**TECHNICAL DRAINAGE STUDY
UPDATE No. 2
Skye Canyon Phase 3 Infrastructure**
City of Las Vegas, Nevada

Job No.: OLY1602.000
Date: January 2018

Subject: Technical Drainage Study Update No. 2 for Skye Canyon Phase 3 Infrastructure (DS 4796)

14'x7' RCB Culvert Entrance Concrete Plug Detail

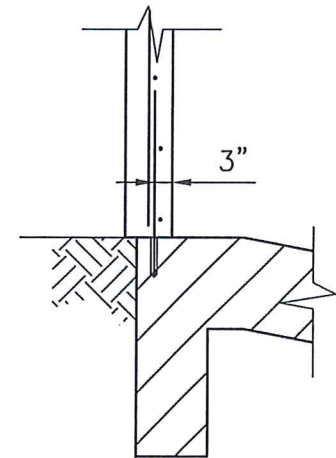
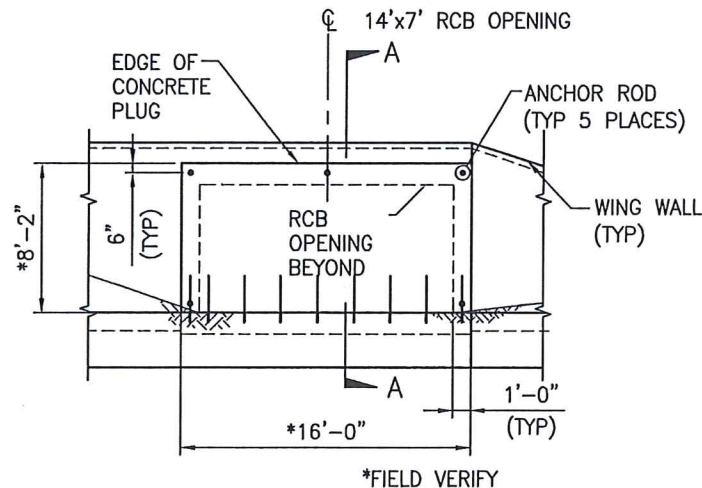
The purpose of this study is to cancel the storm drain revisions proposed with the Update No. 1 Study and propose the new solution of moving the driveway entrance to the south. The updated improvement plans (Appendix C) show the revised location of the driveway. With this solution, the culvert crossing is no longer in conflict with proposed onsite improvements. Instead of being removed, the interim 14' x 7' RCB entrance is now proposed to be blocked with a concrete plug (see Appendix A) and backfilled.

SD-05
SHEET 23 OF 57
DWG NO. 107Y5044

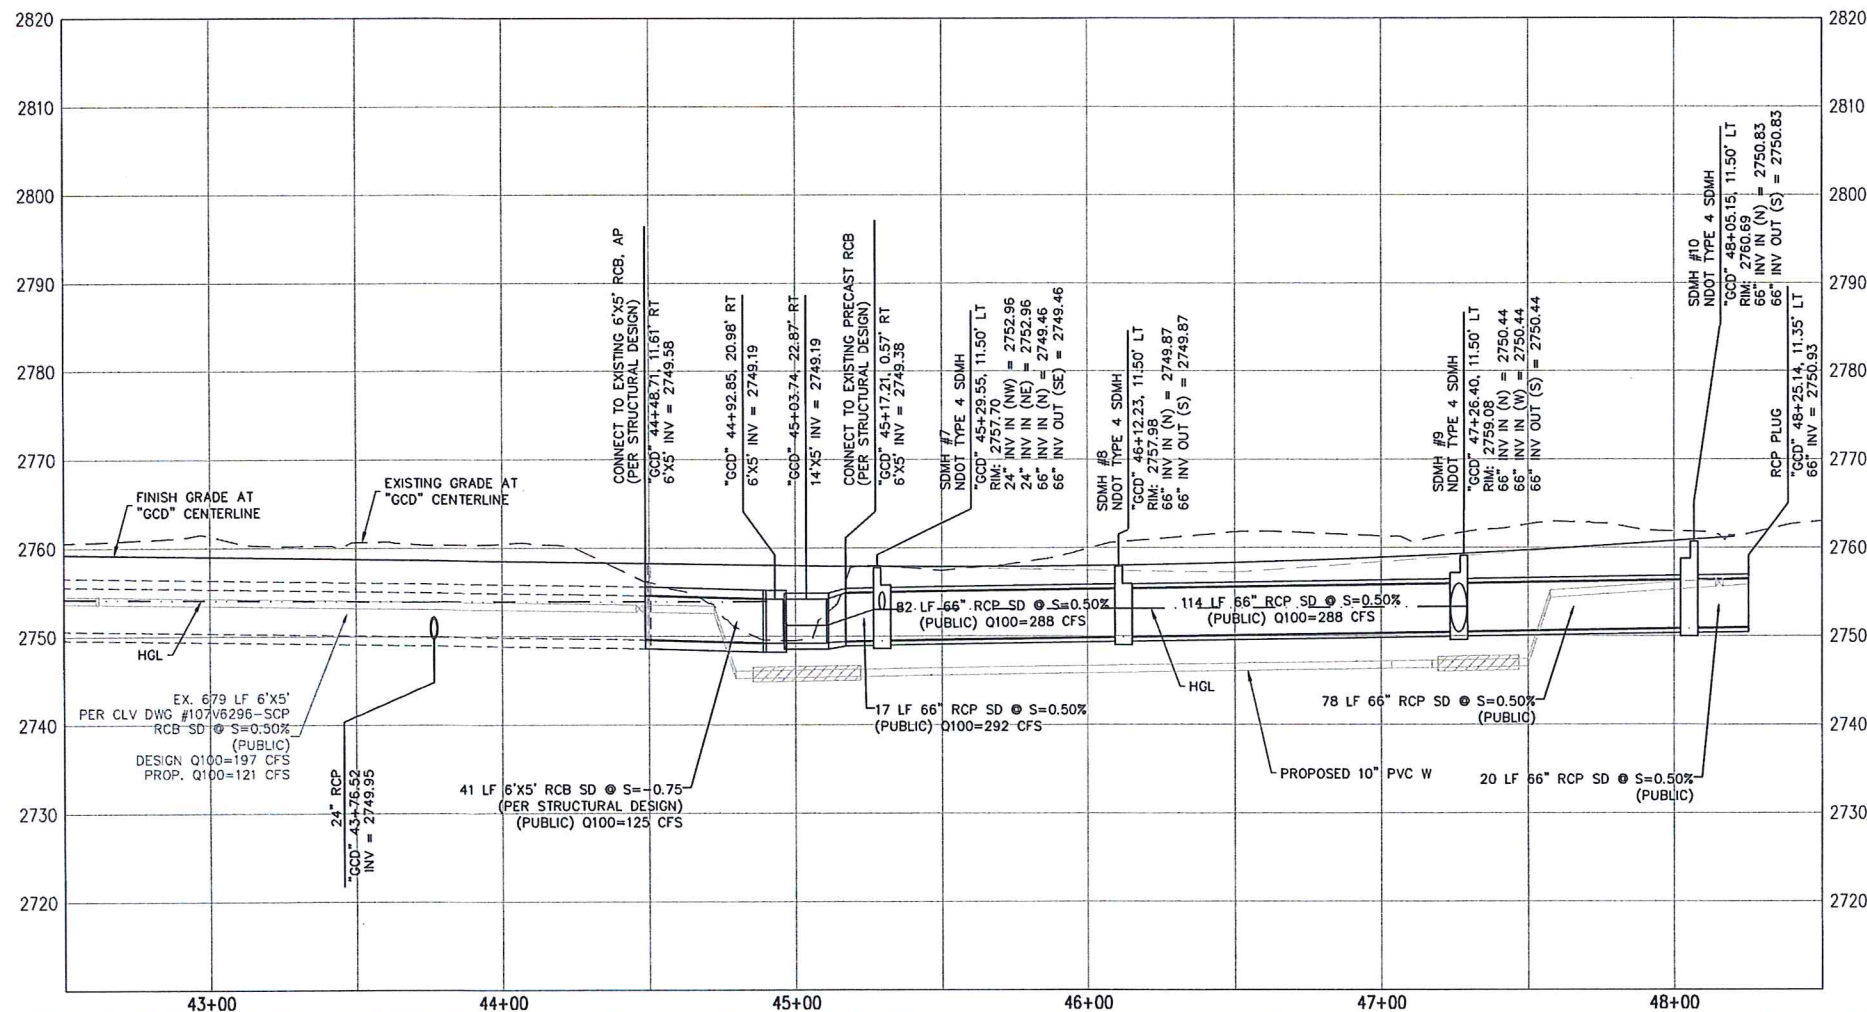
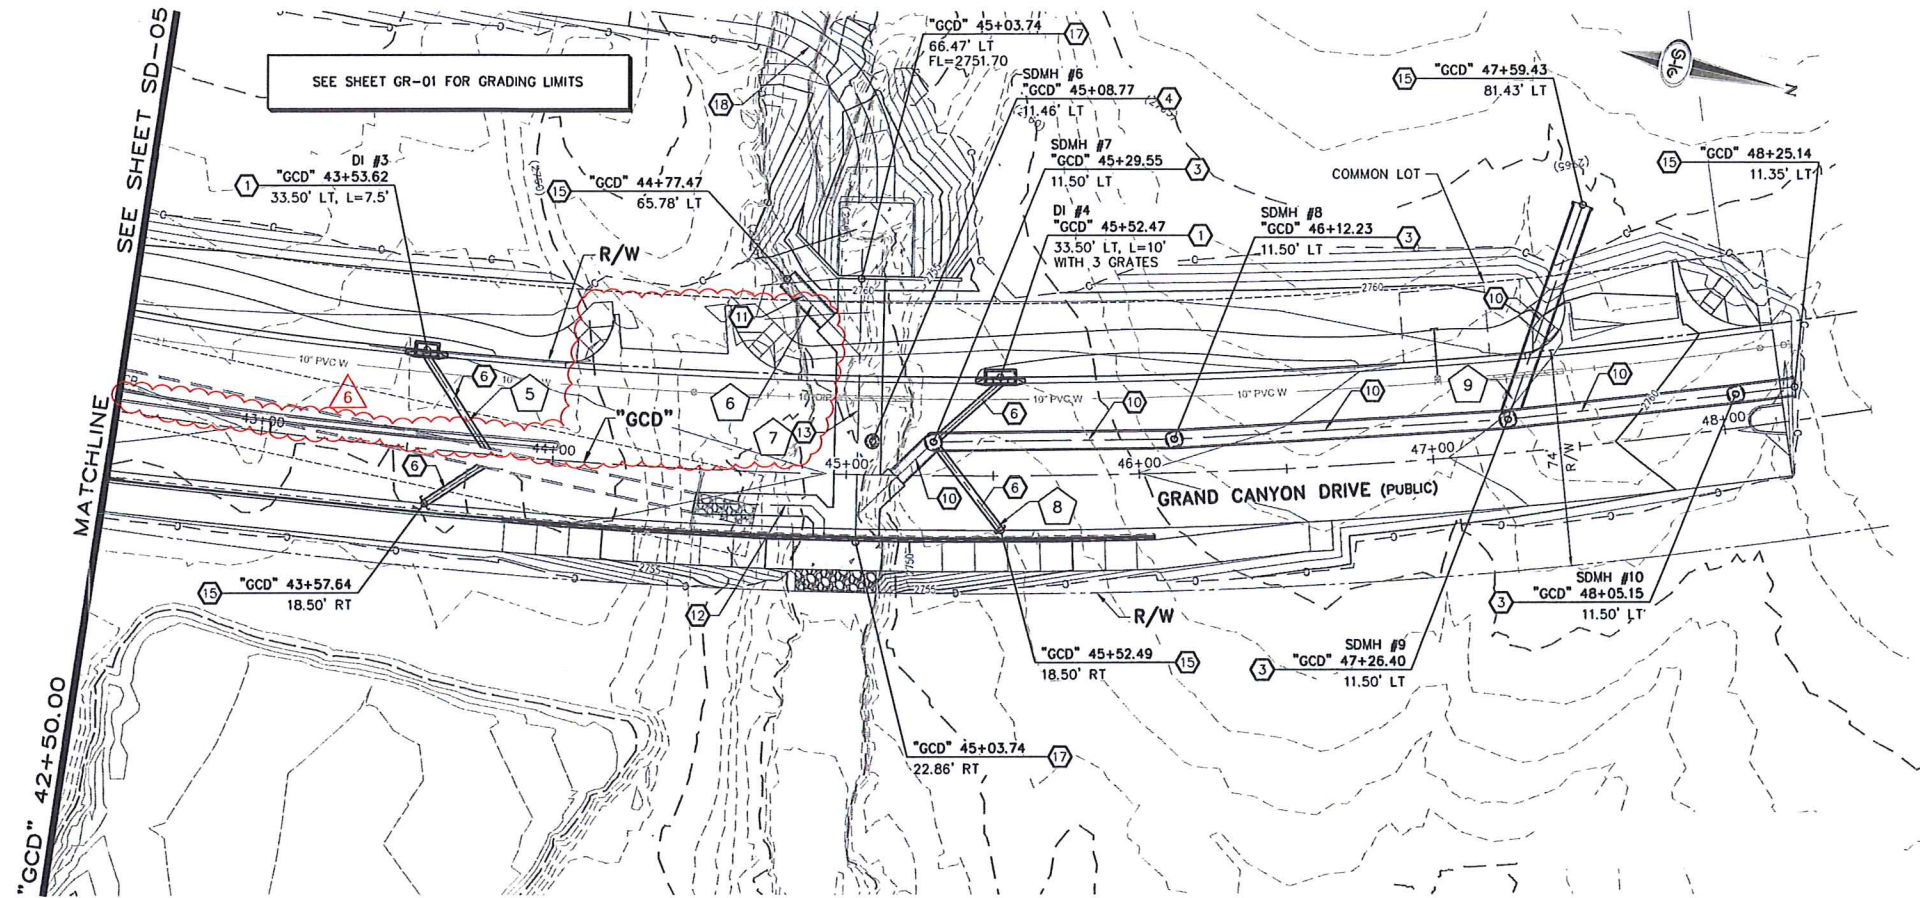
The replacement revision will be submitted this week. We are sliding the driveway approximately 50' south. This will put the storm drain pipe in a landscaped area where the landscaping will be mounded to cover the top of the exposed pipe. You should get this revision Wednesday or Thursday this week.
